CHAPTER IV

TEXT CHANGES TO THE MITIGATED NEGATIVE DECLARATION/INITIAL STUDY

The following text changes are made to the Mitigated Negative Declaration/Initial Study and incorporated as part of the Mitigated Negative Declaration/Initial Study. These include both text changes made in Section III of this document in response to comments, and staff-initiated text changes and errata. Additions to text in this section are shown as underlined, and deletions to the text are noted by strike-through lines.

Boundary of the SDG&E Miramar Yard combustion turbine site

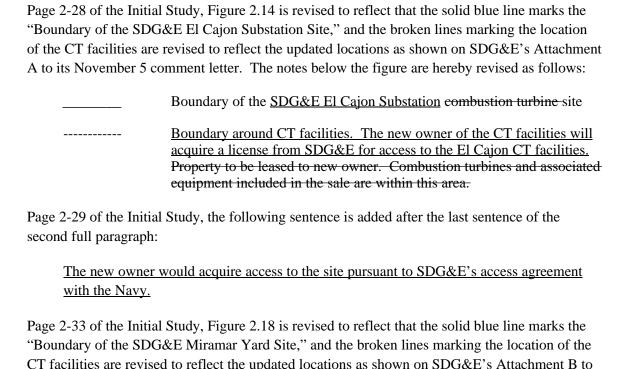
its November 5 comment letter. The notes below the figure are hereby revised as follows:
